August 3, 1984

HOPE CREEK GENERATING STATION  
DOCKET NO. 50-354  
DRAFT SAFETY EVALUATION REPORT  
OPEN ITEM STATUS

In addition, enclosed for your review and approval (see Attachment 4) are the resolutions to the Draft SER open items, FSAR question responses and structural geotechnical audit item responses, listed in Attachment 3.

**FIGURE A-13-2**  
**RESPONSE SPECTRA COMPARISON,**

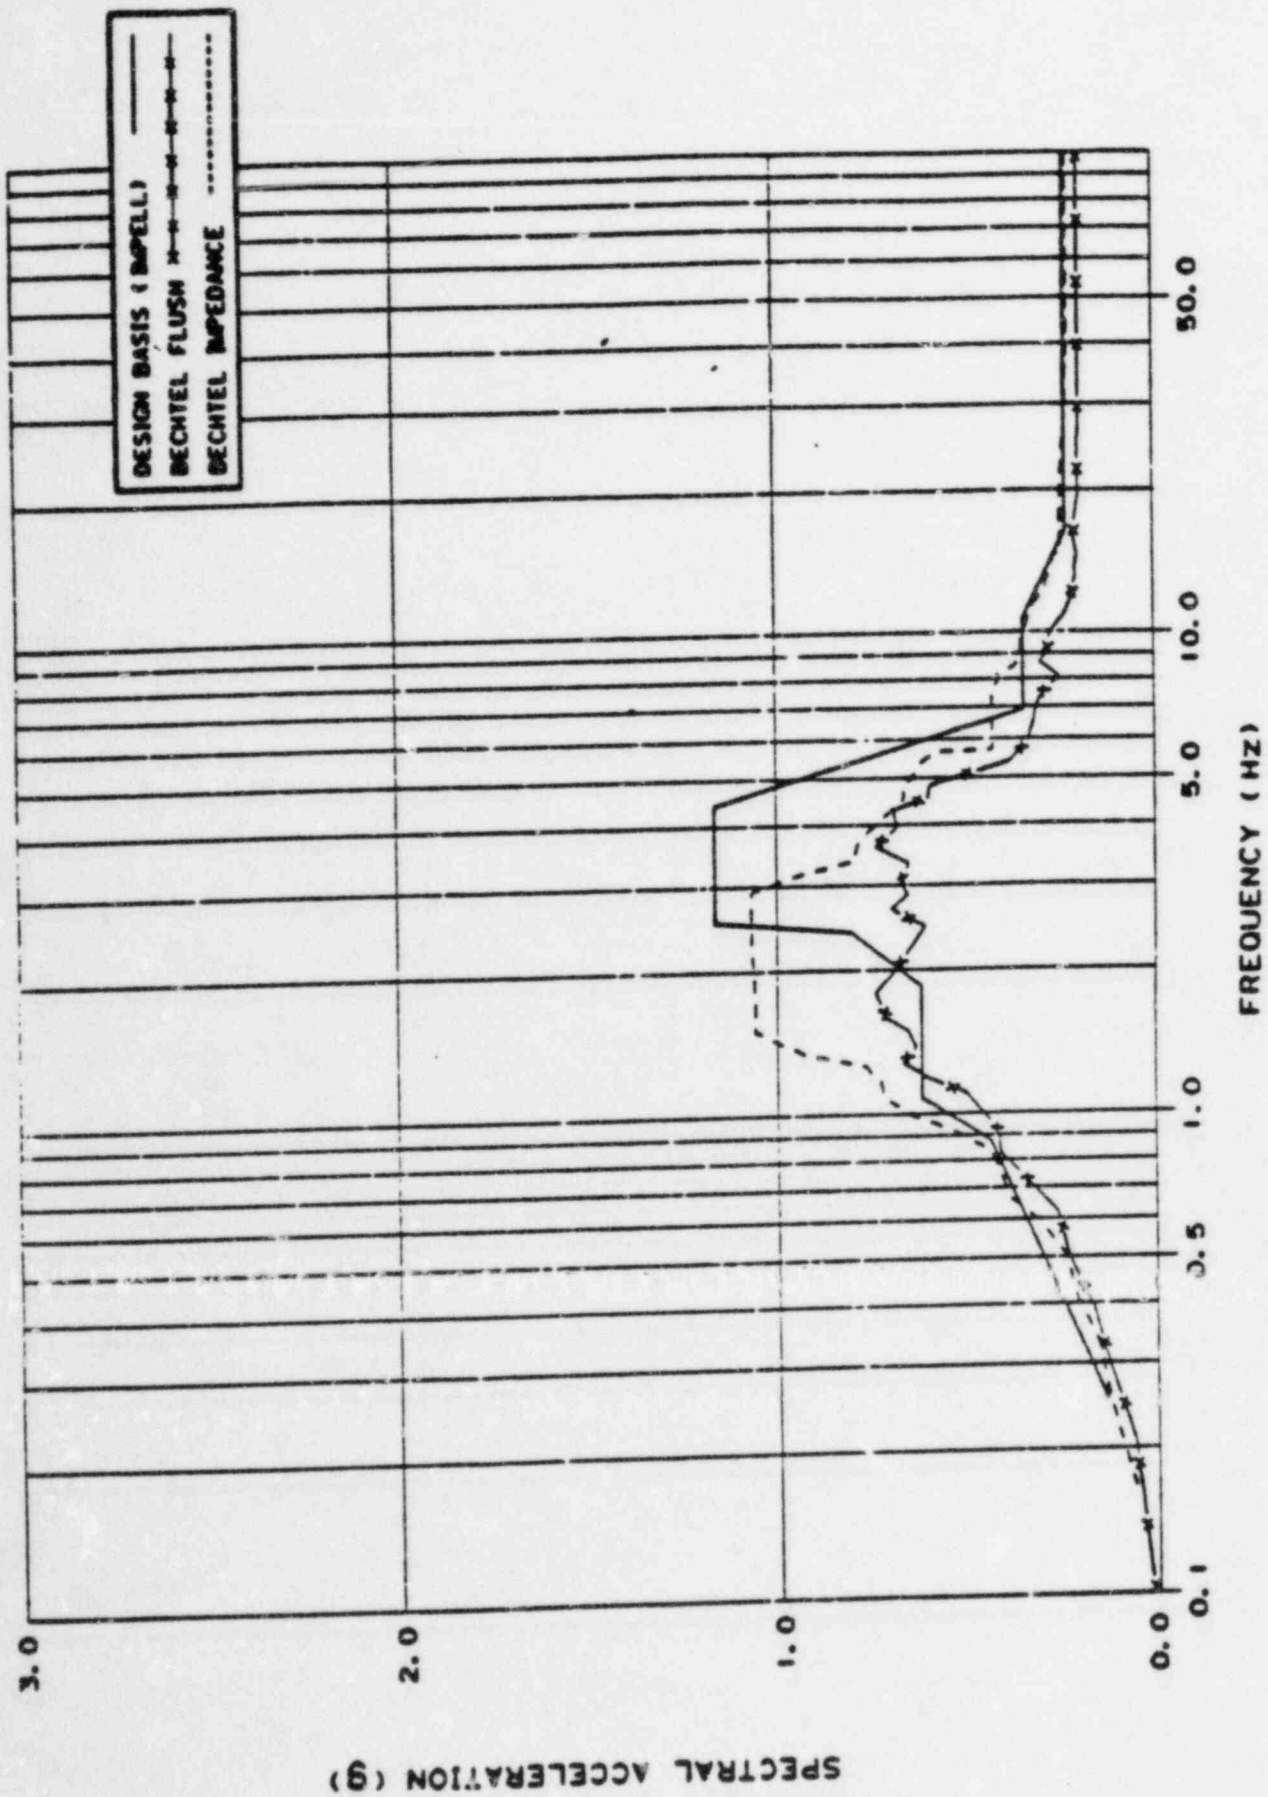
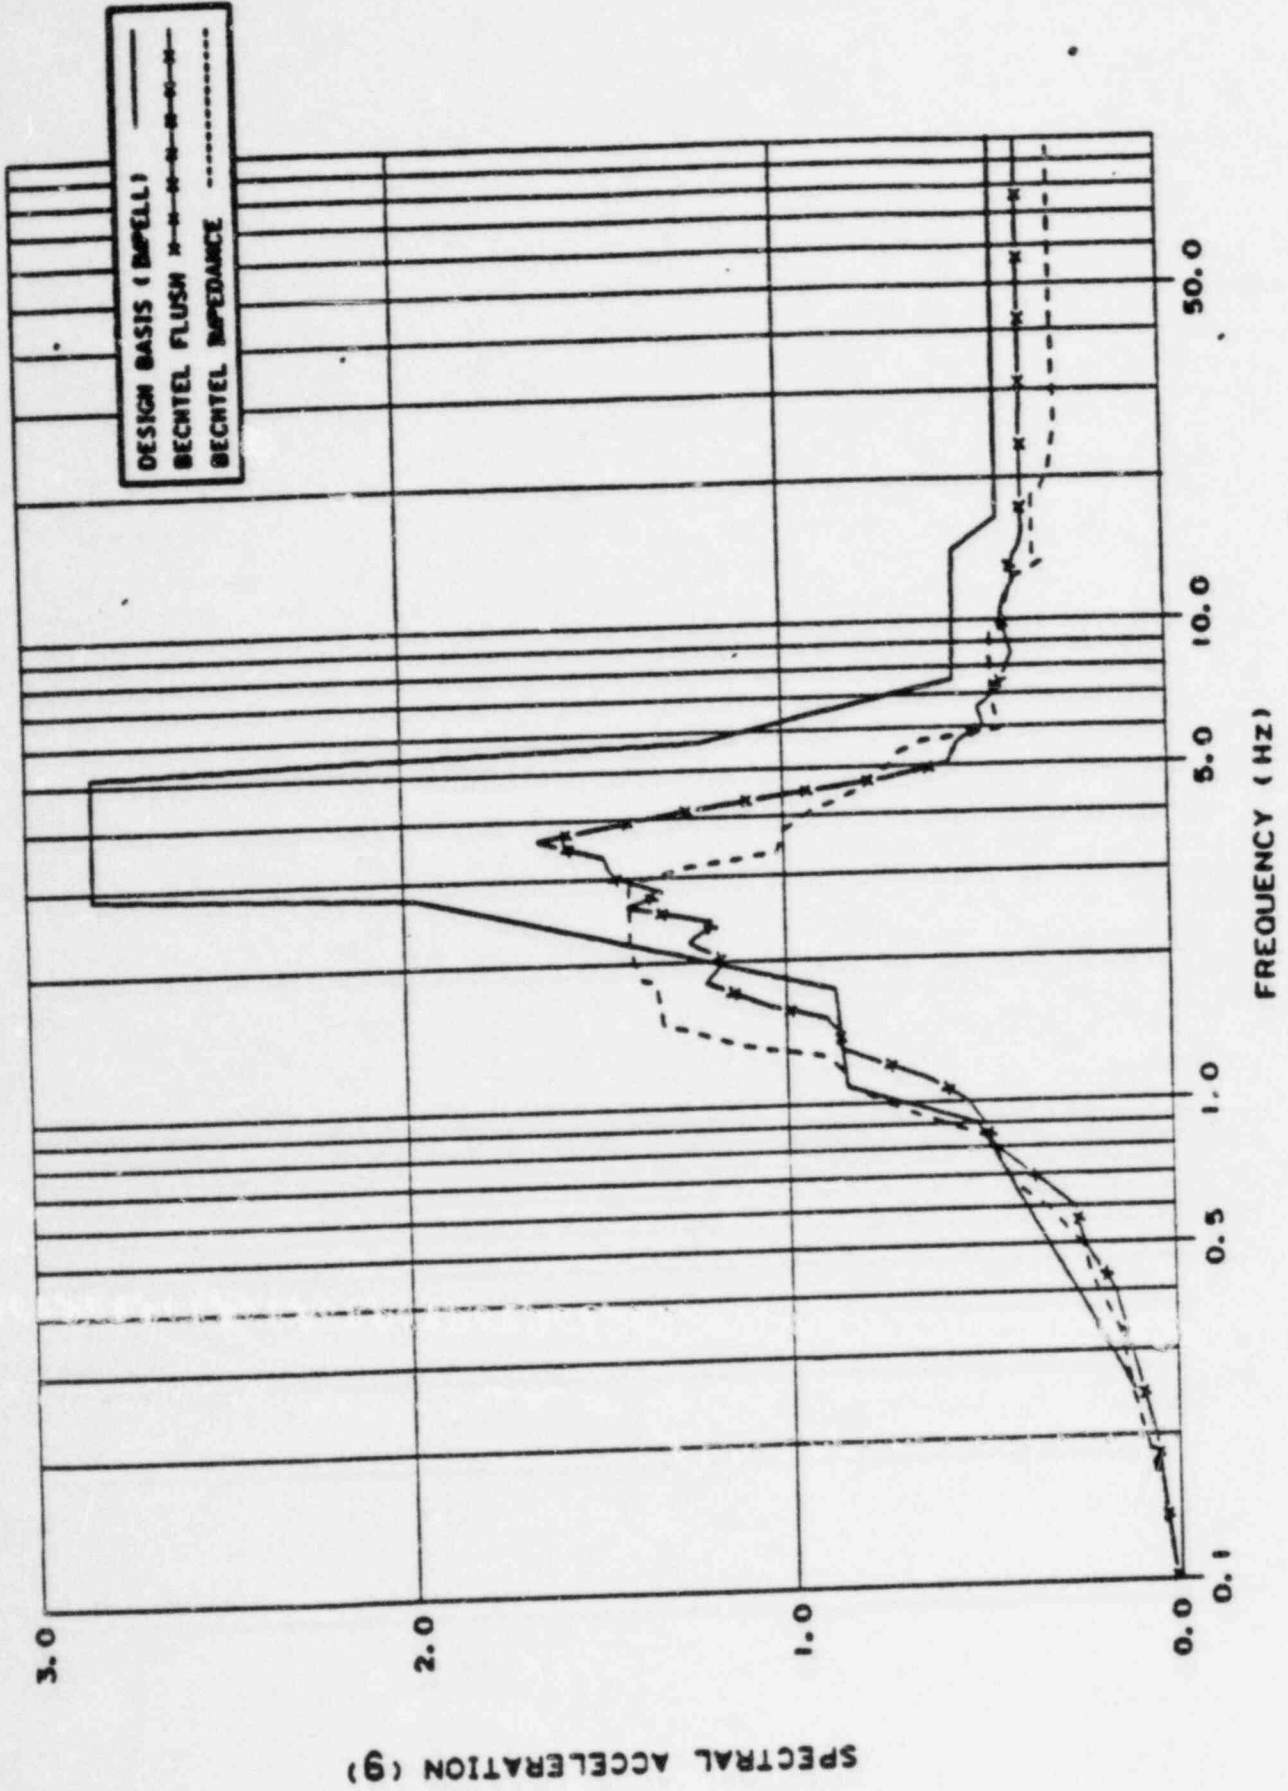
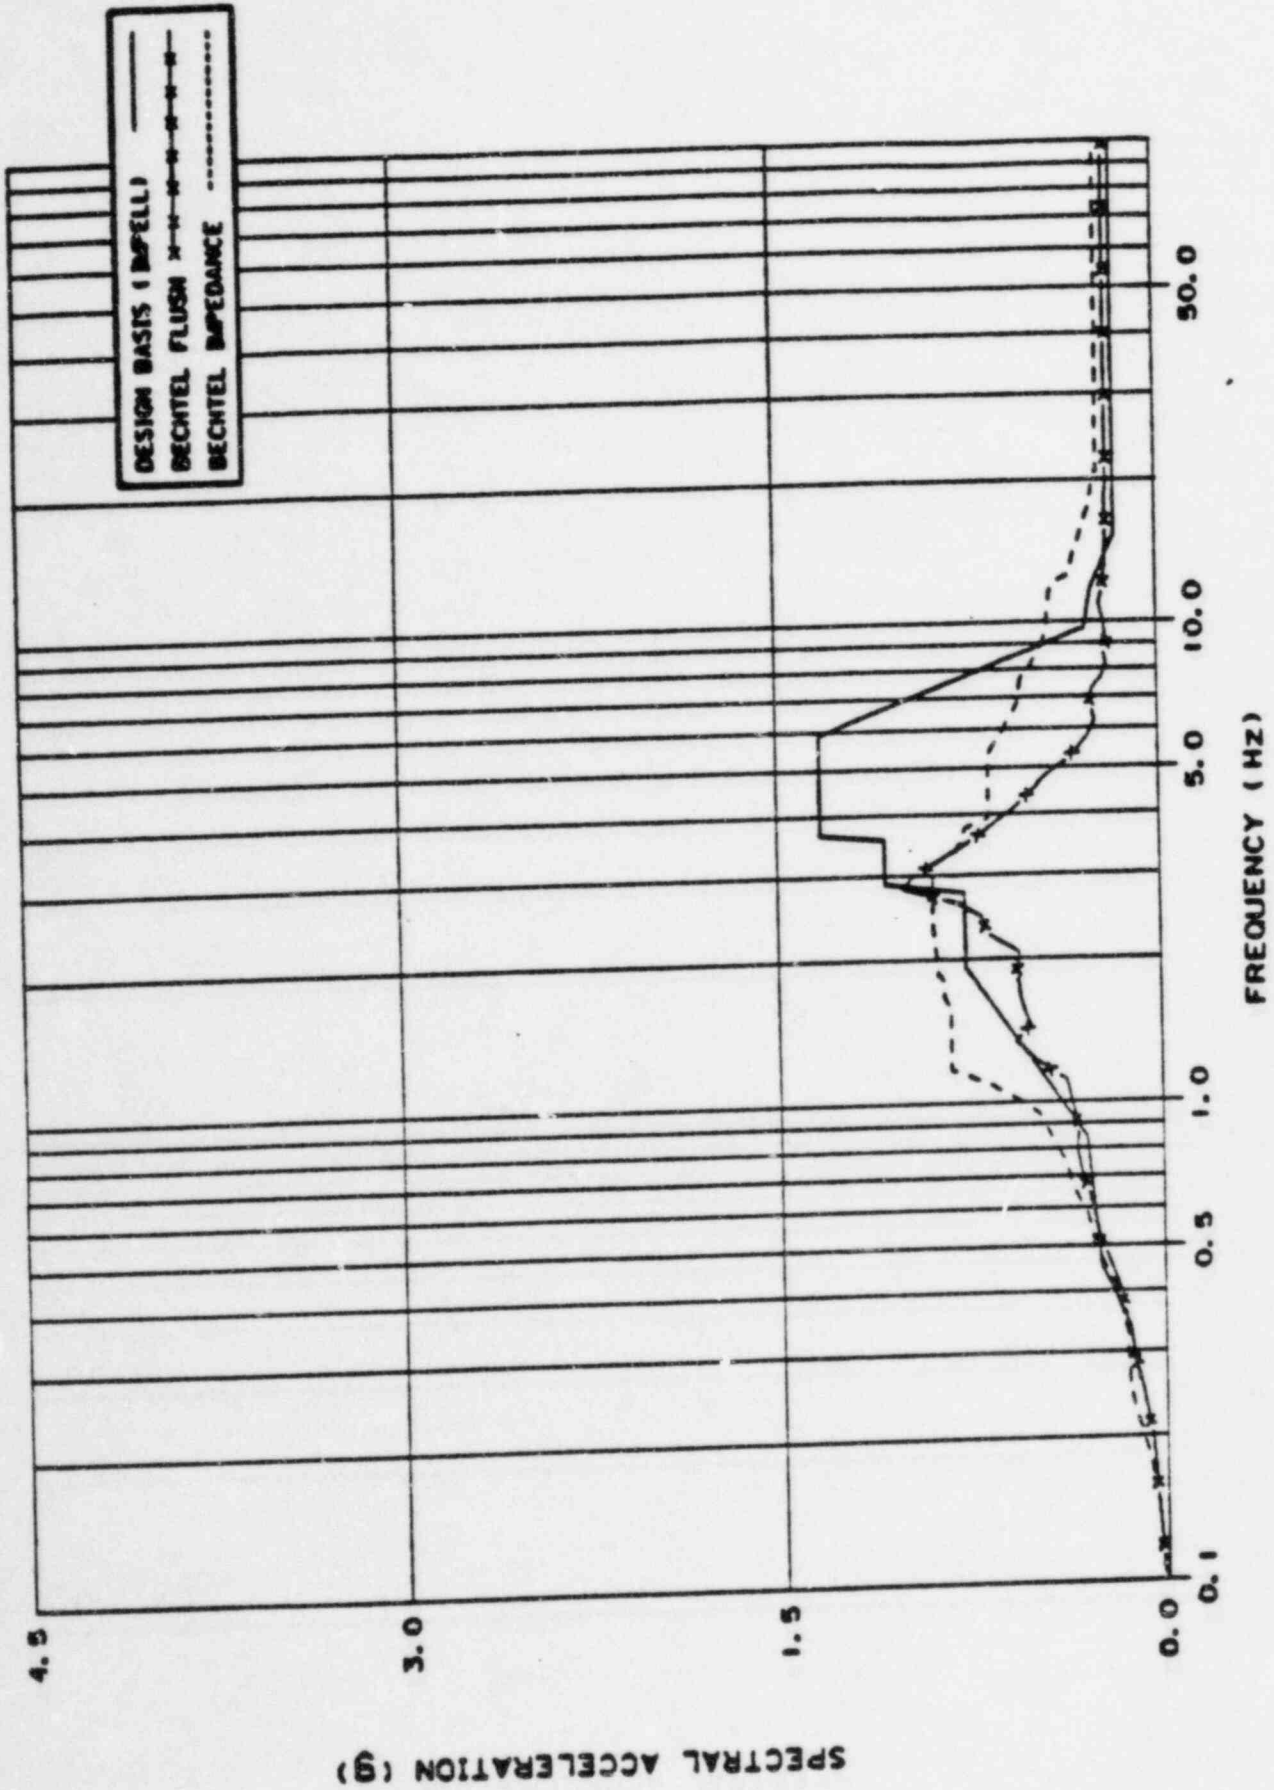
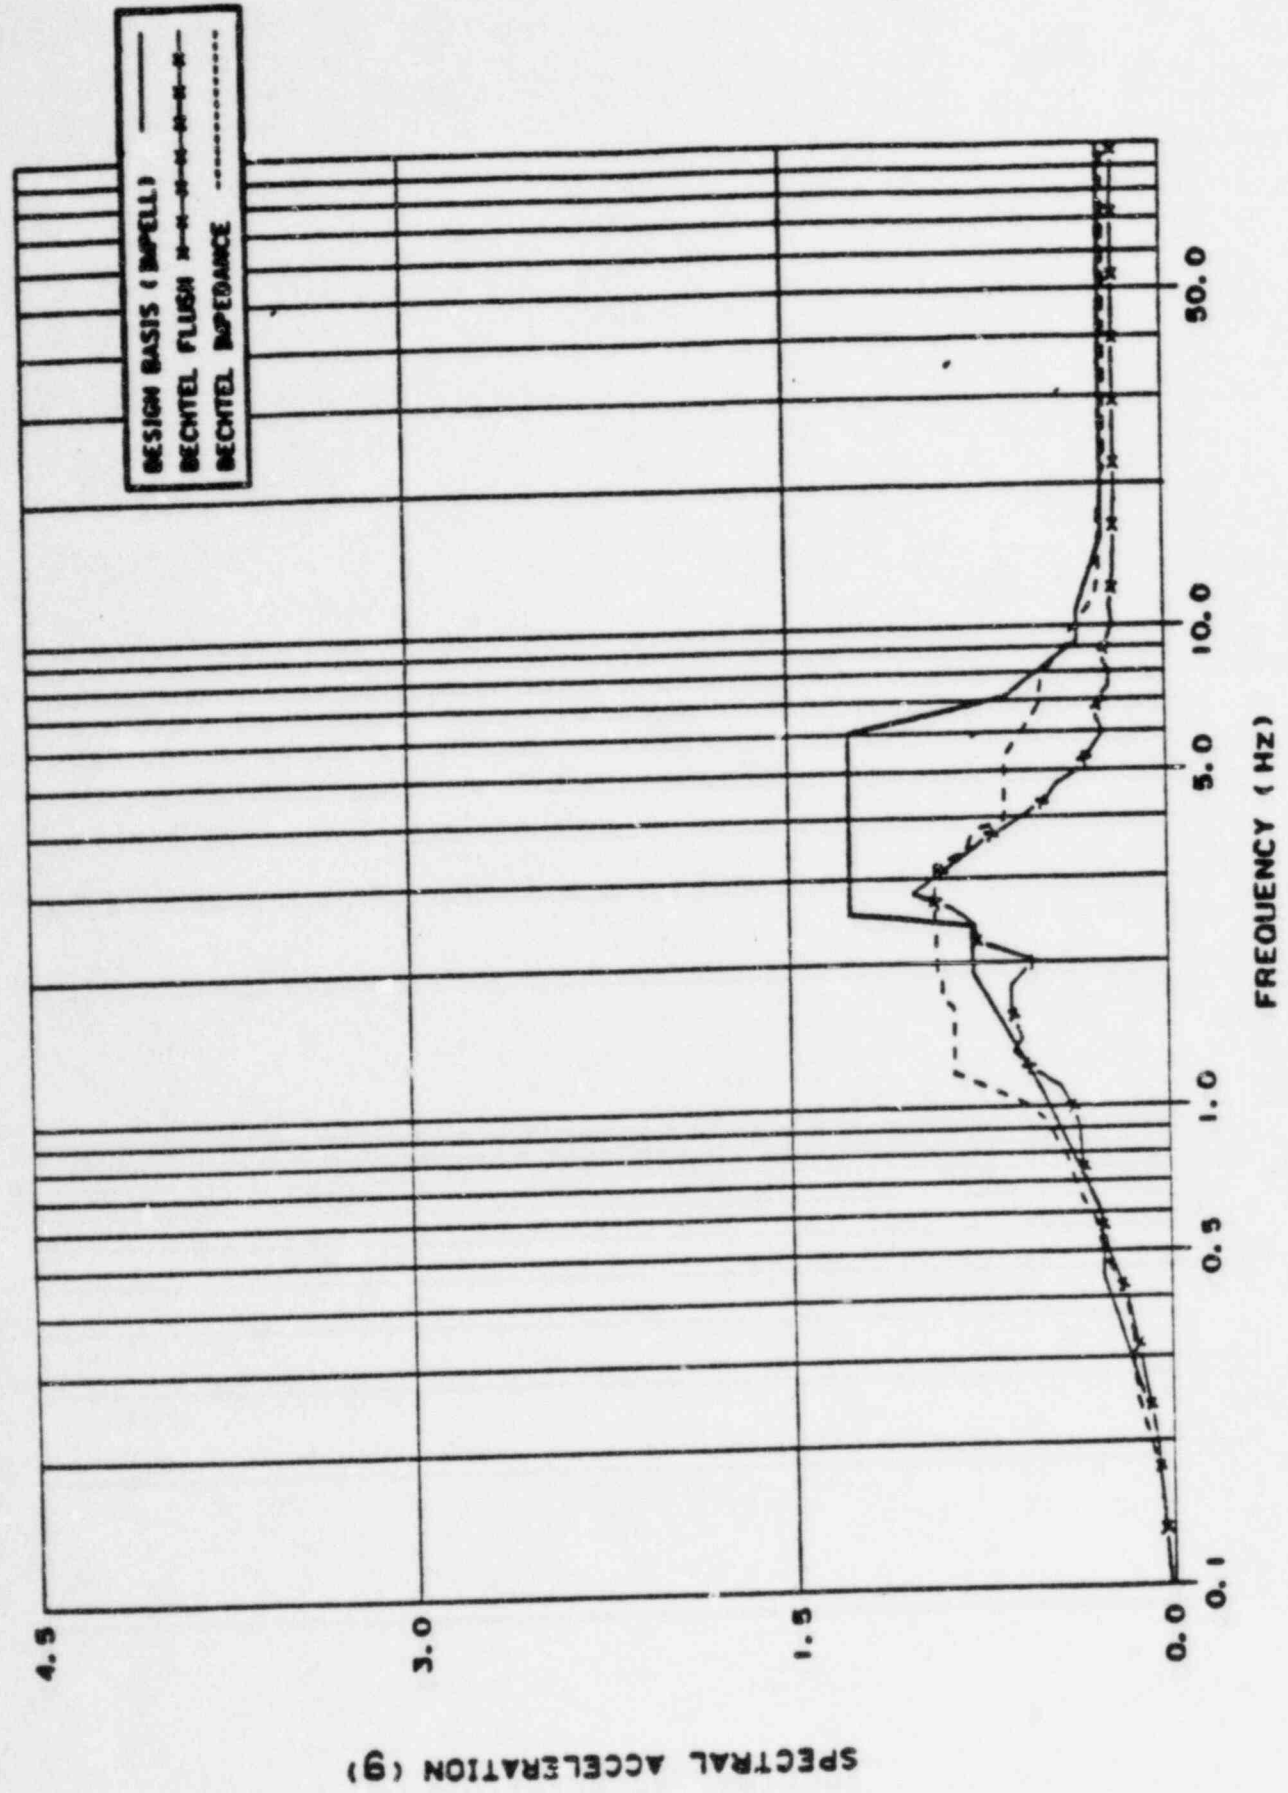
Question: Provide comparison of Bechtel Independent Verification Results with the Design Basis Results.

Figures A-13-2 to A-13-37 show the comparison of the response spectra (2% damping) obtained from the above three seismic soil-structure interaction analyses. Discussions of these comparisons are as follows:

Bechtel's independent soil-structure interaction analyses are performed using the computer code FLUSH. The results of independent finite element analyses are in reasonable agreement with those of the design basis analyses. As can be seen from Figures A-13-2 through A-13-37, the horizontal response spectra obtained from the independent finite element analyses are generally enveloped by those obtained from the design basis analyses except for the frequency range lower than 2 Hz. The vertical response spectra showed some exceedances at the frequency range of 18 Hz. These exceedances are listed in Table A-13-1.

The peak spectral accelerations obtained from the impedance approach analyses are generally lower than those obtained from the design basis analyses. However, these response spectra are not completely enveloped by those obtained from the design basis analysis, especially in the frequency range between 1.0 and 3.5 Hz. Also, there are some local exceedances in the higher frequency range, as shown in Figures A-13-2 through A-13-37.
